Service Bulletin

Bulletin No.: 17-NA-217

Subject: Squeal Noise Originating from Front Brakes During Brake Apply

Brand:	Model:	Model Year:		VIN:		Engine:	Transmission:
		from	to	from	to		
Cadillac	XT5	2017	2017			All	All
GMC	Acadia (VIN N)	2017	2017			All	All

4261515

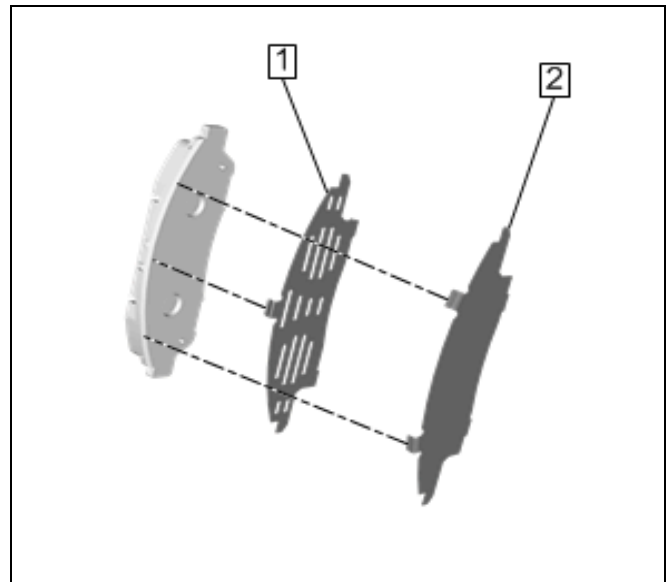
Involved Region or Country	North America and N.A. Export Regions
Condition	Some customers may comment on a squeal noise from the front brakes during brake apply.
Correction	Apply a coat of paste between the shims of the front brake pads.

- 2. Apply 2-4 grams of lubricant grease between the shims of both the inboard and outboard pads of the front calipers.
- 3. Reinstall components and verify the condition is corrected.
